Norfolk Vanguard Project EN010079 ref. 20012468
Norfolk Boreas Project EN010087 ref. 20022983

I would like to take this opportunity to highlight the necessity of an independent design review of the combined Vanguard and Boreas substation projects.

This scale diagram shows the 4 converter halls alone of Boreas/Vanguard would be equivalent to 8 Angels of The North.

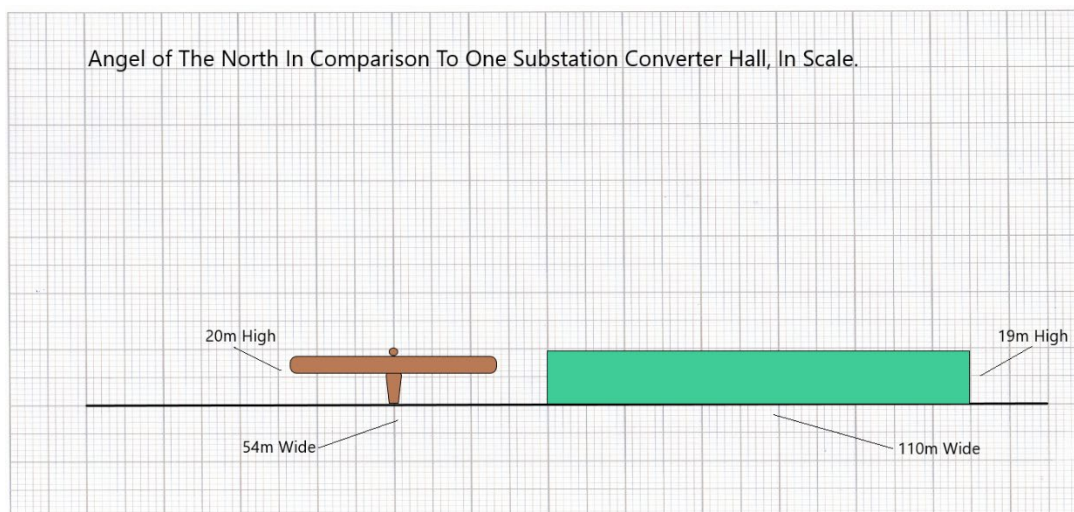
This admits the visualisations are a representation of a probable underestimation of the scale of the converter buildings and a blue dotted box represents how large they could possibly be. This is not clearly explained, and is therefore very misleading.

[6.2.29.25%20Environmental%20Statement%20Figure%2029.25%20Scenario%201%20-%20Viewpoint%203%20Lodge%20Lane%20north.pdf](https://infrastructure.planninginspectorate.gov.uk/wp-content/ipc/uploads/projects/EN010087/EN010087-000684-6.2.29.25%20Environmental%20Statement%20Figure%2029.25%20Scenario%201%20-%20Viewpoint%203%20Lodge%20Lane%20north.pdf) Demonstrates there is no explanation of the blue dotted box on the visualisation and no way of knowing that the buildings could be that big, It also shows by representing the buildings as an underestimation, but they could be as big as the blue dotted box, that this massive variance makes the visualisations pretty useless.
